Ergon Energy 2025/26 to 2029/30 Regulatory Proposal

# **REVIEW OF ASPECTS OF PROPOSED EXPENDITURE**

Report prepared for:  
**AUSTRALIAN ENERGY  
REGULATOR**  
August 2024

Figure 4.2: Ergon Energy Pole Failure Trends

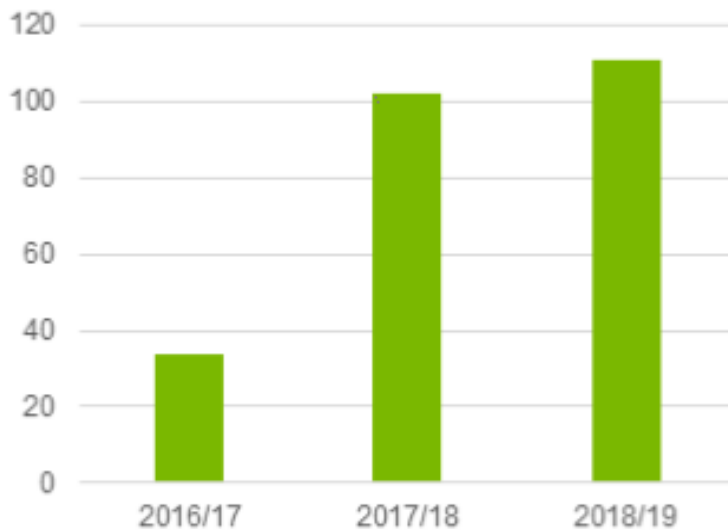
273. Nonetheless a three-year trend of unassisted pole failure is presented in Figure 3 of the business case, reproduced below in Figure 4.2.

Figure 4.3: Energy Queensland Regions 3 Year Rolling Pole Reliability

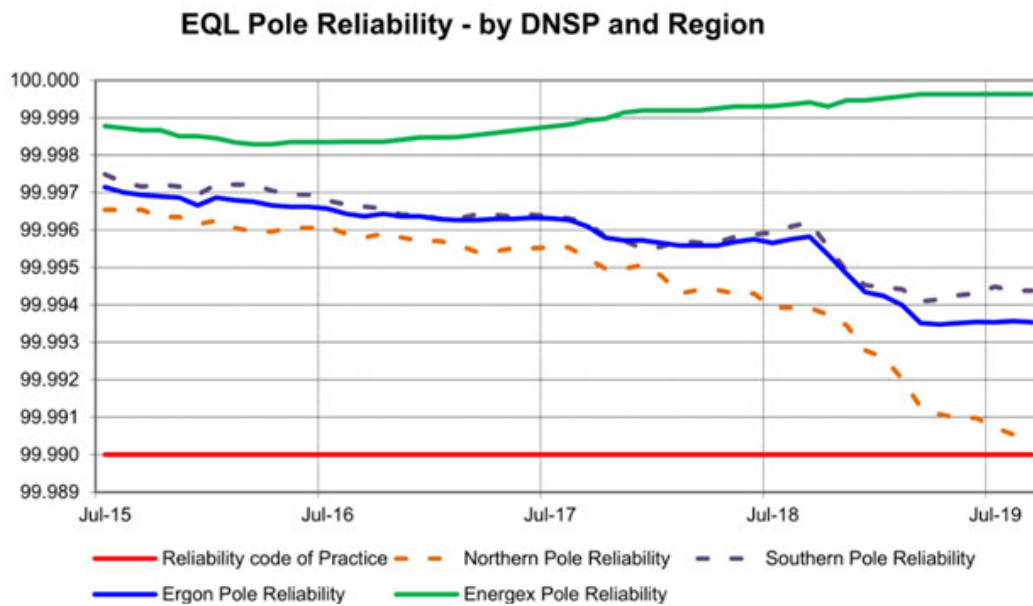
275. The data in the figure provided by Ergon (reproduced as Figure 4.3) does not show a current breach, however as the data from FY17 rolls off, and assuming a similar level of failures as experienced in FY18 and FY19, the breach would reasonably be expected to occur at some time in the near future (as was subsequently the case).

Figure 4.4: Unassisted pole failure FY16 to FY23

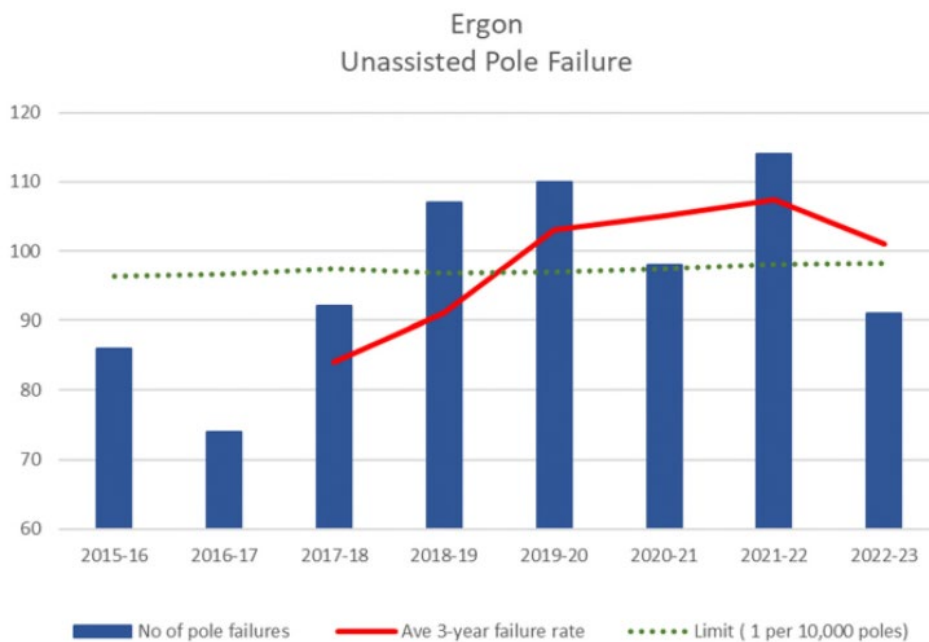
278. According to the updated unassisted pole failure data provided in the 2025-30 RP shown in Figure 4.4, Ergon’s performance has breached the ESCOP target since FY20. But more recently the number of pole failures shows signs of reducing to within target in the next few years.<sup>72</sup>

Figure 4.9: Historical pole defects

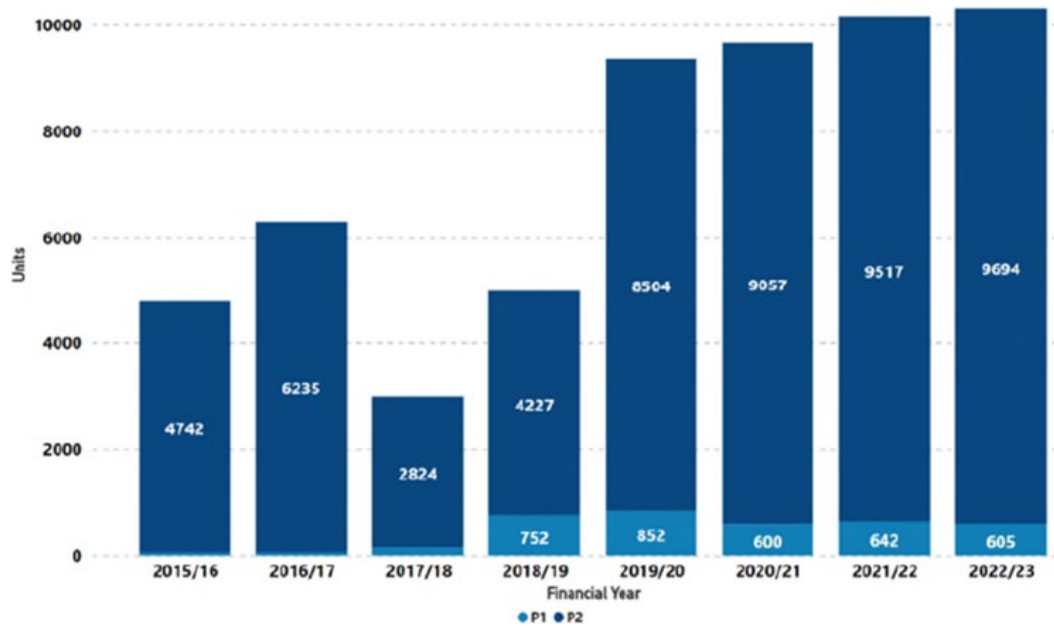
358. The increase in defect numbers is clearly evident in Figure 4.9 from FY20, due to the changes that Ergon had made to its serviceability assessment.

Figure 4.10: Pole and pole top replacement trends

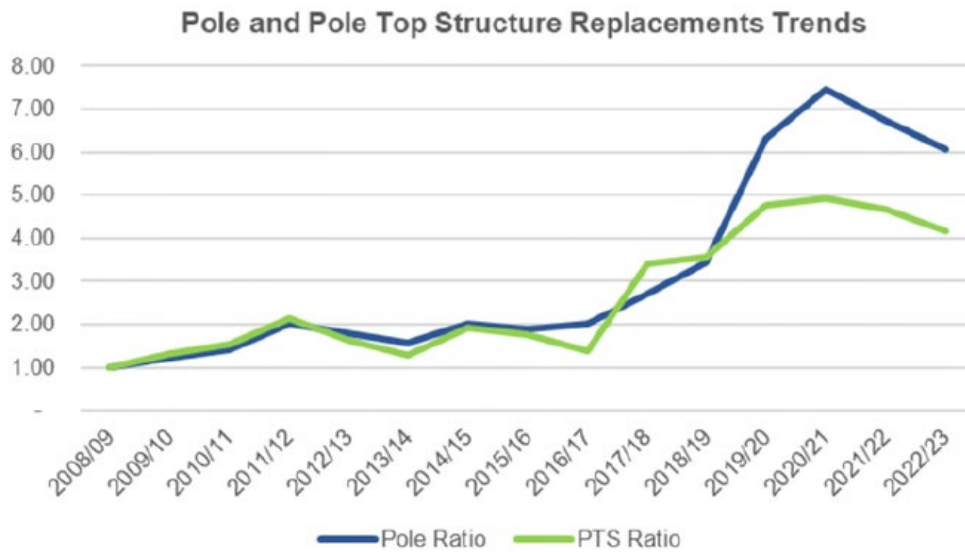
380. We understand that this chart shows the increase in pole and pole-top structure replacement relative to the FY09 volume, to determine whether the increase from that point is well correlated – that is, has a direct relationship. Figure 4.10 shows a well correlated relationship between the replacement of poles with pole-top structures. We expect the higher pole replacement trend from FY20 was likely the result of a higher proportion of rural Single Wire Earth Return (SWER) poles, where a crossarm is not included, and therefore not required to be replaced.

Figure 4.12: Historical and forecast unit rate for service lines, \$FY25

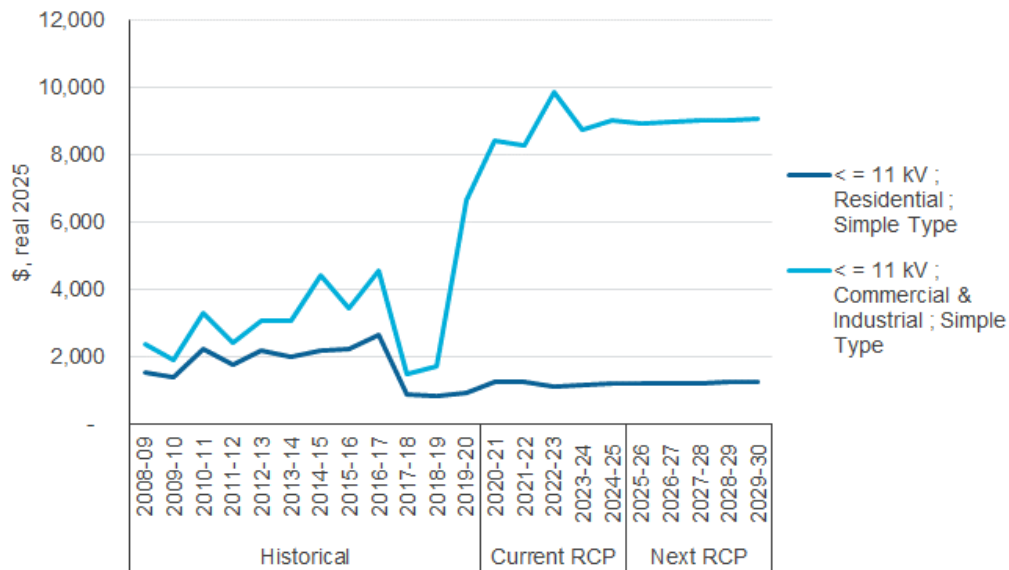
399. The basis of the change in unit rate relative to the RRP is not explained by Ergon. Our review of the RIN information reveals that the calculated unit rate for commercial service lines varies significantly from the historical rate, commencing FY20, as shown in Figure 4.12. It has the effect of increasing the average unit rate for all service lines.

Figure 4.13: Distribution transformer defects P1 and P2

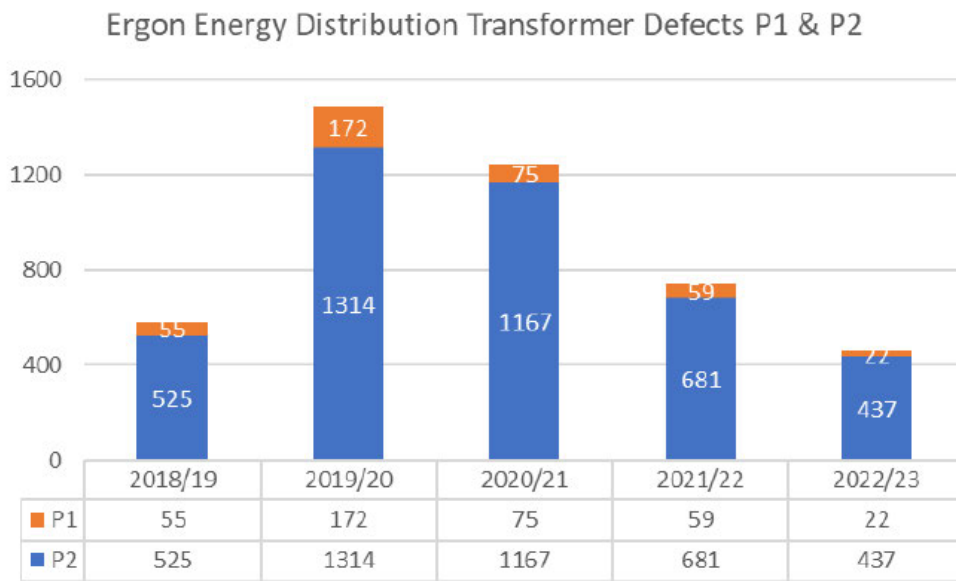
410. In Figure 4.13, we show the historical trend of defect-driven replacement and refurbishment works that have been conducted on distribution transformers. The profile of defects does not align well with the incurred expenditure, assuming the P1/P2 defects are resolved in the year they are identified.

Figure 4.14: Distribution Transformer Replacement Data

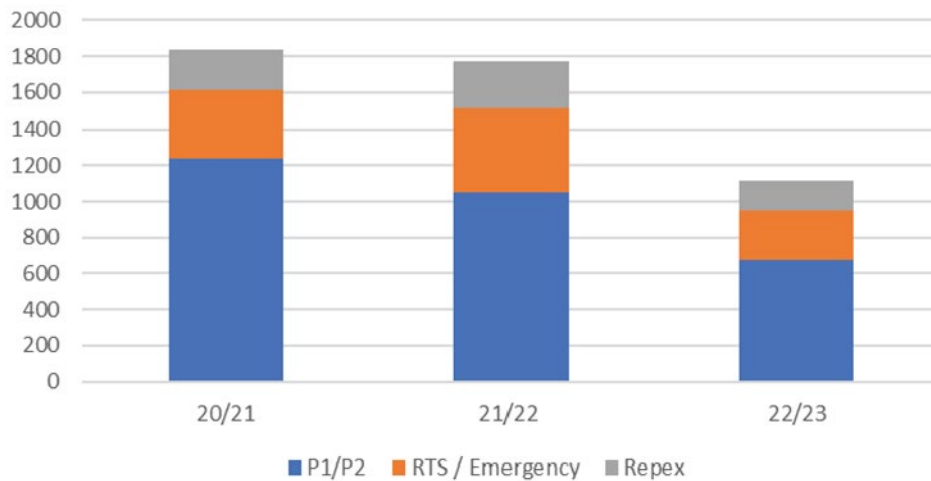
413. We have reproduced Figure 4.19 referred to by Ergon as Figure 4.14 below, which shows a replacement level of 1000 units p.a. included in the 2020 Board submission, towards the end of the 3-year period shown. We consider that ‘opportunistic’ replacement may have contributed to a higher replacement level and associated repex than a prudent and efficient level in previous years.

Figure 4.15: Switchgear replacement volumes

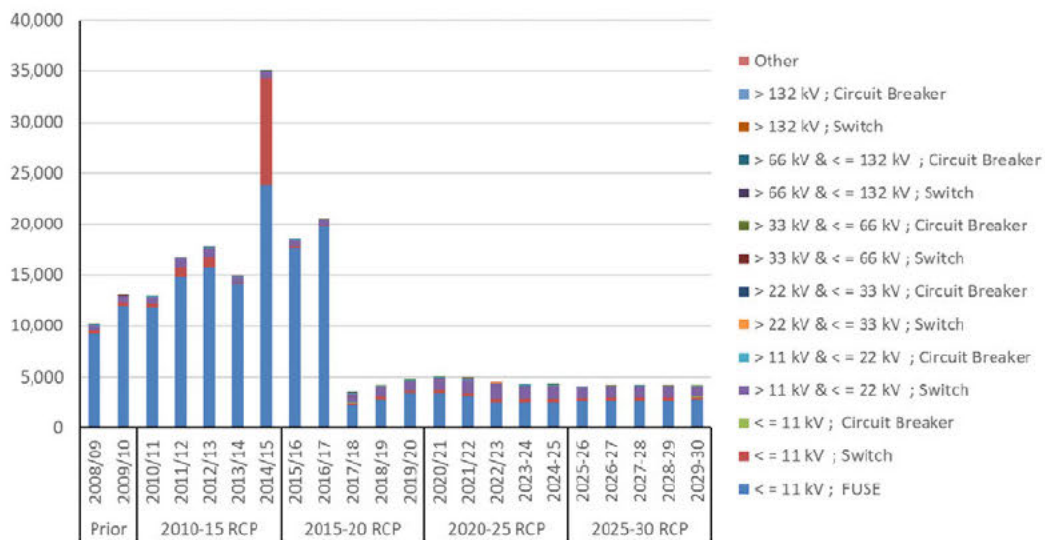
436. We observe a distinct change in volume (lower) and unit rate (higher) of distribution switch replacement. On review of the RIN data in Figure 4.15, this appears to relate to a significant reduction in the volume of <=11kV fuse units, but an increase in expenditure and which is not explained in Ergon’s documentation. We would expect, given the materiality of the change, that Ergon would have included a description outlining the change in treatment, or how this may be reflective of a change in asset management strategy or accounting treatment for this item.

Figure 4.18: Pole top structure unit rates (\$FY25)

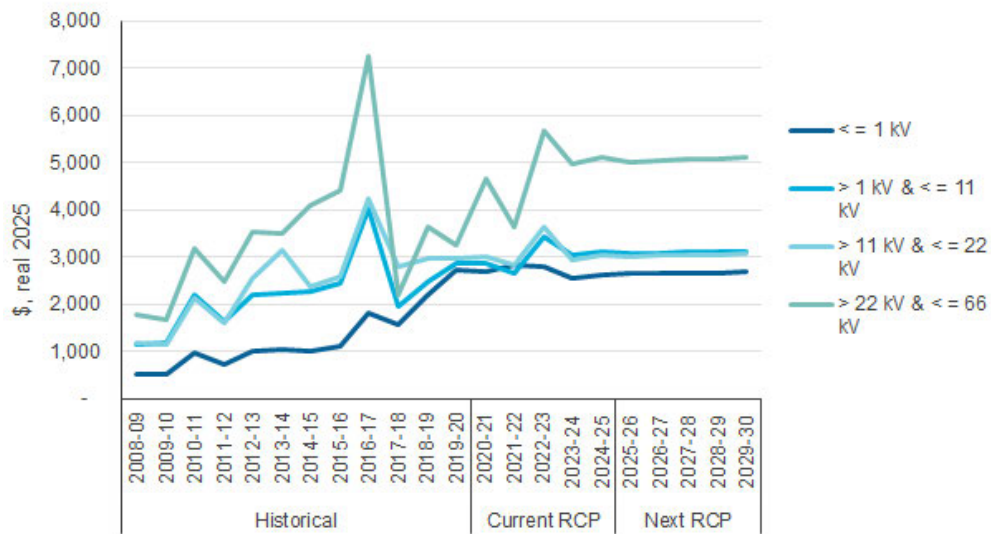
461. Figure 4.18 shows that the rates for pole top structures has been increasing, with the largest increases evident for low voltage (LV) structures which are not explained. Accepting the possible data errors prior to FY18, whilst the unit costs for high voltage (HV) remain relatively stable, the unit cost for LV crossarms is increasing. We would expect this to remain relatively stable, and perhaps reduce over time due to increased volumes associated with the large pole replacement program.

Figure 4.19: Switchgear – fuses unit rates (\$ FY25)

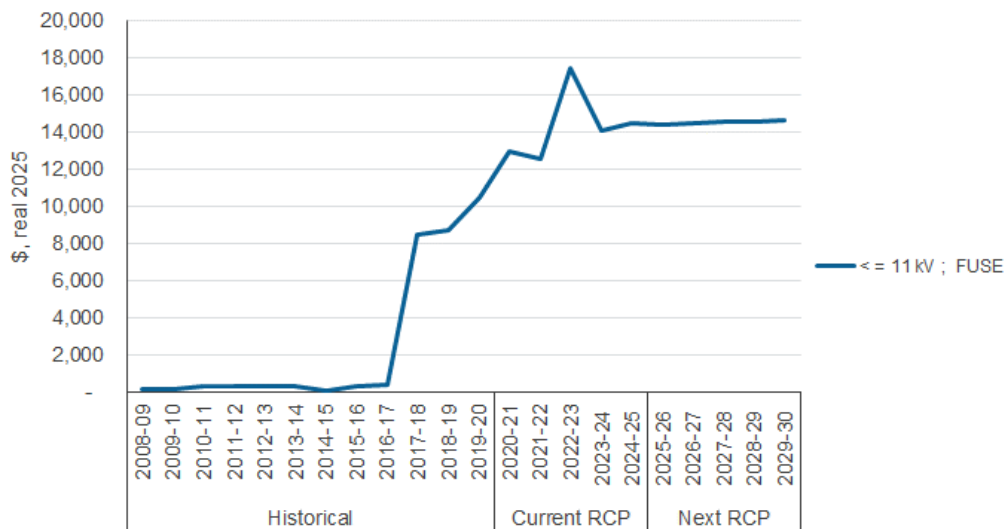
462. Figure 4.19 shows fuse unit rates, and which we discuss in our review of the switchgear asset category. The average unit cost is the result of changes in expenditure and volume at the same time, and which suggest to us that there has been a change in reporting for switchgear that may assist to explain the large increase. Fuses comprise expendable cartridges and fuse units and which vary significantly in cost, and collectively represent a large expenditure item that is not explained.

Figure 5.1: Historical and forecast repex (\$m, FY25)

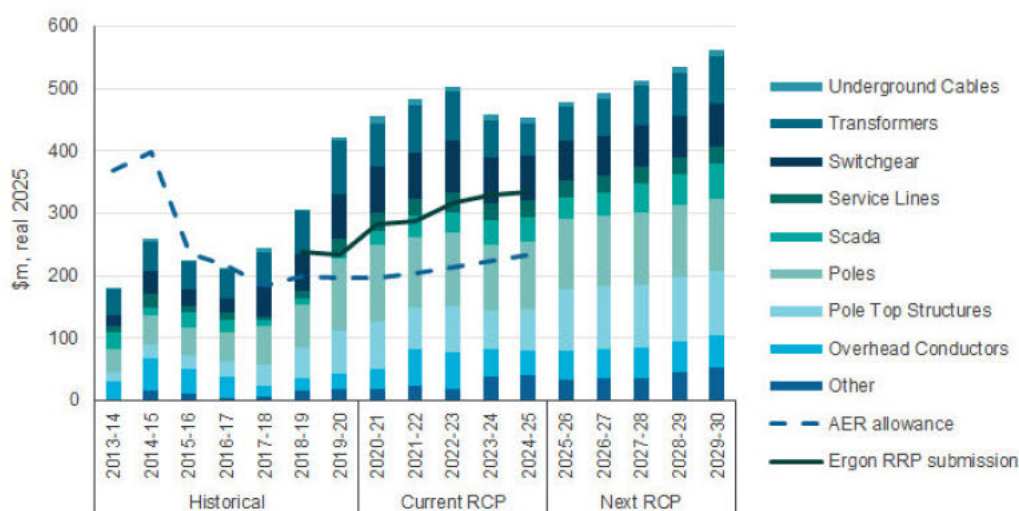
487. In Figure 5.1 we observe the increase in repex commencing in FY19 to approximately \$300 million, then again in FY20 to \$410 million, and continuing at above this level in each year for the current RCP.
488. For the next RCP, Ergon’s proposed repex results in a trend increasing year on year to a final value of \$560 million by FY30, driven by year on year increases for the transformer, SCADA and other repex categories.
489. Figure 5.2 compares Ergon’s annualised average repex for each expenditure category between the next RCP and the previous and current RCPs. This figure highlights the significant step increase in annualised repex that Ergon is incurring in the current RCP, and the further increase that it proposes for the next RCP.

Figure 5.5: South Toowoomba – Optimum timing based on comparison of annual benefits against annuitised cost (\$m Dec22)

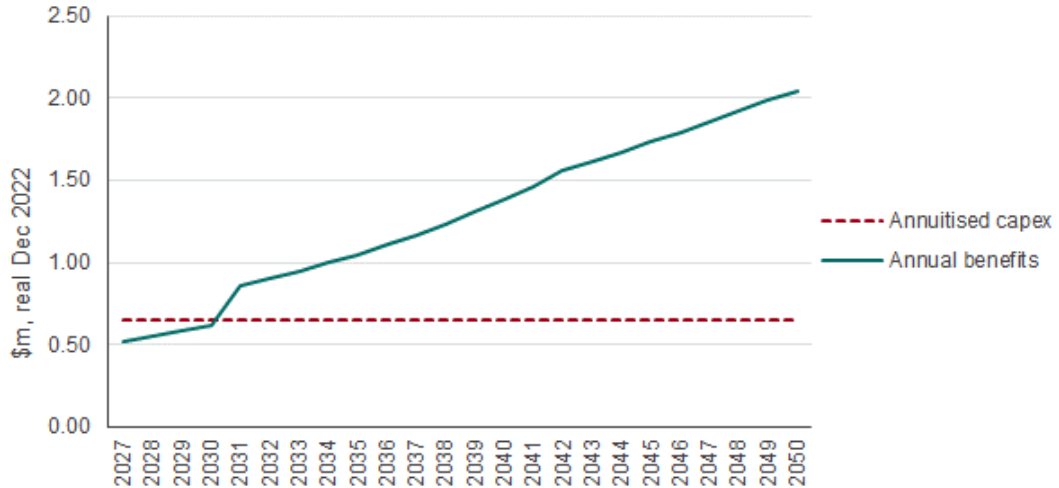
beyond the assumed date of 2027 that its NPV modelling was based on. We found this same result for each of the four options that Ergon had considered.

Figure 5.6: Neil Smith substation, Option 1 (preferred): Optimal timing based on comparison of annual benefits against annuitised cost (\$m Dec22)

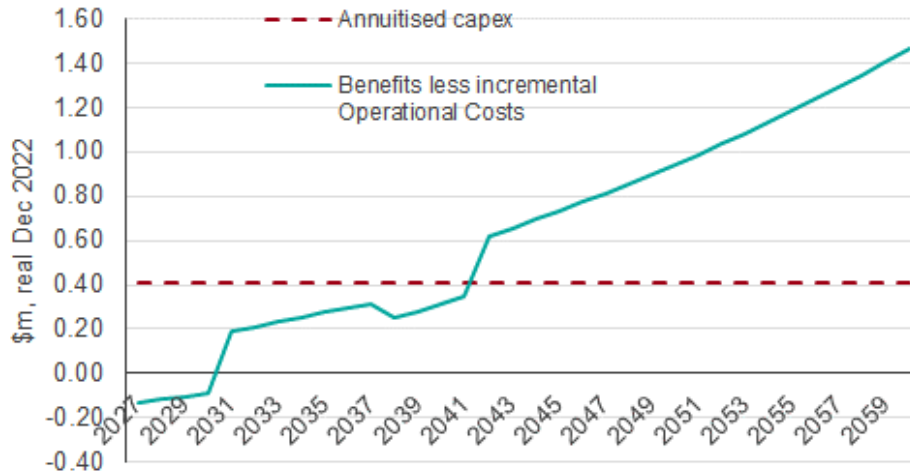
523. As with SOTO, we undertook an assessment of the economically optimal timing for this project, using the costs and benefits that Ergon provided in its cost benefit model. The results of this assessment are illustrated in Figure 5.6, and show that from an economic viewpoint, the option that Ergon has proposed would not be justified until 2042.

Figure 5.7: Neil Smith substation, Option 3: Optimal timing based on comparison of annual benefits against annuitised cost (\$m Dec22)

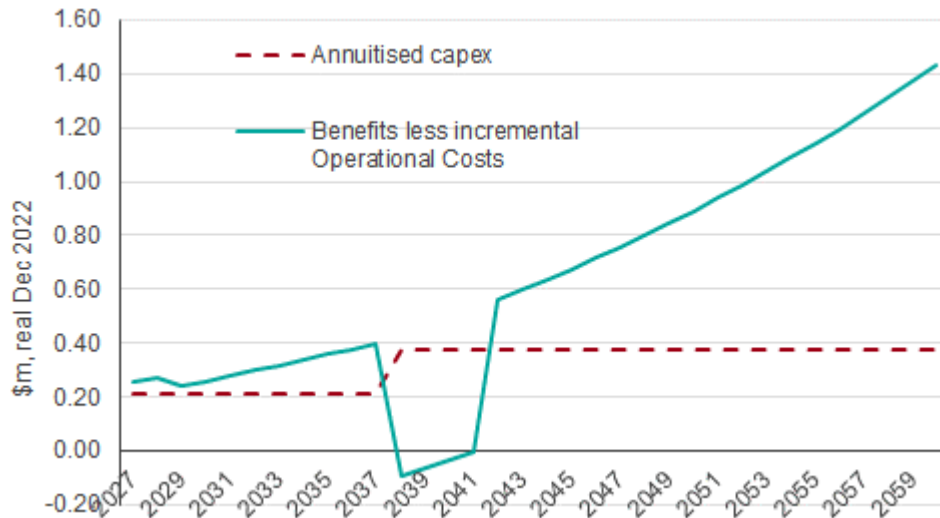
524. We undertook a similar analysis of Ergon's 'Option 3', which has a much lower cost of \$5.25 million (\$Dec22) in the next RCP, compared with \$10.2 million (\$Dec22) for Option 1 which Ergon has proposed. The analysis shows that Option 3 would be viable within the next period, as shown in Figure 5.7. Under option 3, there is a 'stage 2' requirement for further expenditure of \$9.4 million (\$Dec22) in 2038, which shows as a negative deviation from 2037 in Figure 5.7 under Ergon's specification of this option, however as shown our economic timing assessment suggests that this should optimally be deferred to 2042. Regardless of the need and timing for Option 3 Stage 2, the NPV of this is \$12.2 million, compared with \$12.85 million for Option 1 and, on the basis of timing assessment, Option 3 presents as preferred to Option 1.

Figure 6.2: Comparison of conductor clearance program (\$m, FY25)

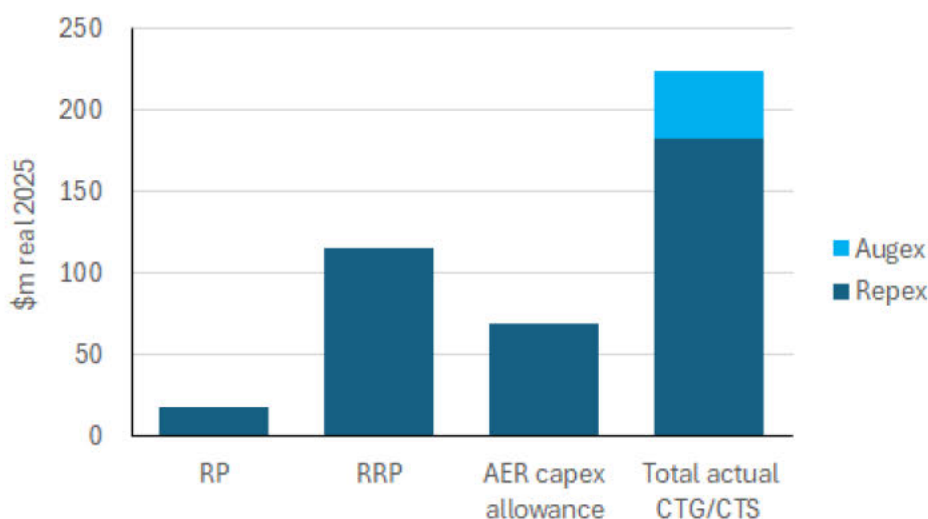
713. Ergon has reclassified its clearance program as an augex program from FY22, consistent with treatment of the clearance program at Energex. Ergon states that the change in classification from a repex program to an augex program is to better align with the driver of this type of expenditure. We have made an adjustment in Figure 6.2 to reflect the total CTG/CTS in the above.

Figure 6.6: Ergon and Energex records of substation DC system failures.

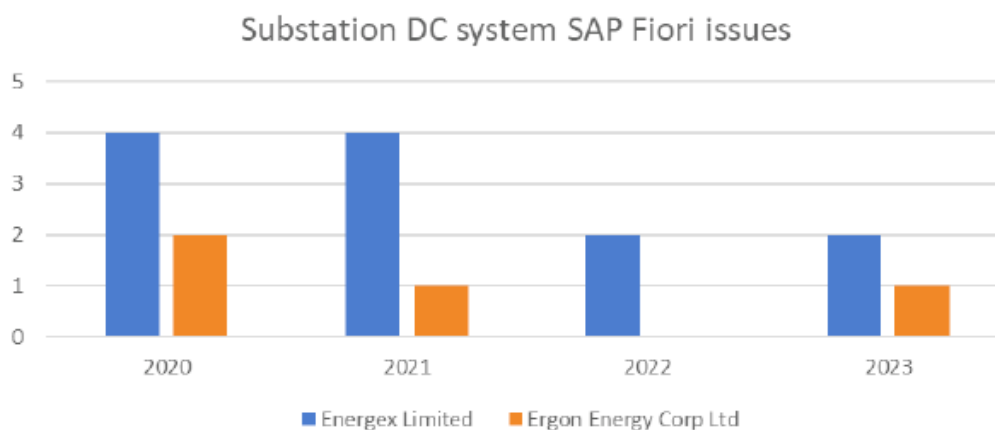
835. Notwithstanding that a bus protection scheme is based on several elements, this method relies on the failure rate of the protection relay as the starting point. Ergon has not demonstrated that the failure rate of bus protection schemes is effectively moderated by a factor of 75%, given their low occurrence. For DC system failures, EQ's SAP records show that DC system failure incidents are relatively rare, especially for Ergon at 1 to 2 per year as shown in Figure 6.6.
